IN THE DRAWINGS:

The attached sheets of drawings include changes to FIGS. 2, 7 and 7A. These sheets, which include FIGS. 1-2 and 7-7A, replace the original sheets including FIGS. 1-2 and 7-7A.

Fig. 2

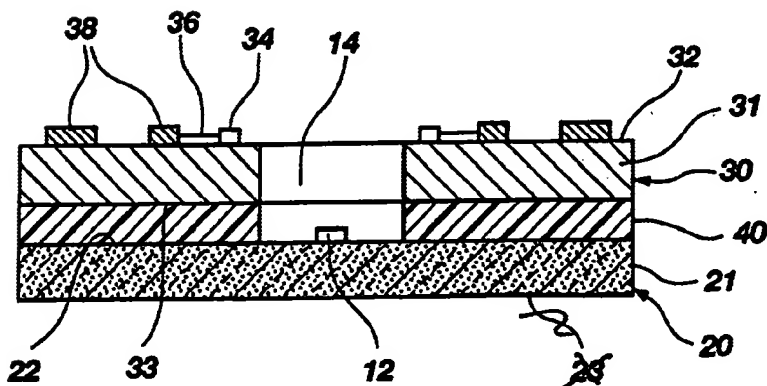
Specifically, FIG. 2 has been revised to delete the reference numeral "23" and its corresponding lead line; FIG. 7 has been revised to delete one of the lines within first small hole 74, to revise the dashed line indicating aperture or slot 14 and to fix the left-hand corner; and FIG. 7A has been revised to increase the height of second wider hole 76 by moving the lowest line to indicate the same height as the edge of substrate element 31 and to fix the left-hand corner. No new matter has been added.
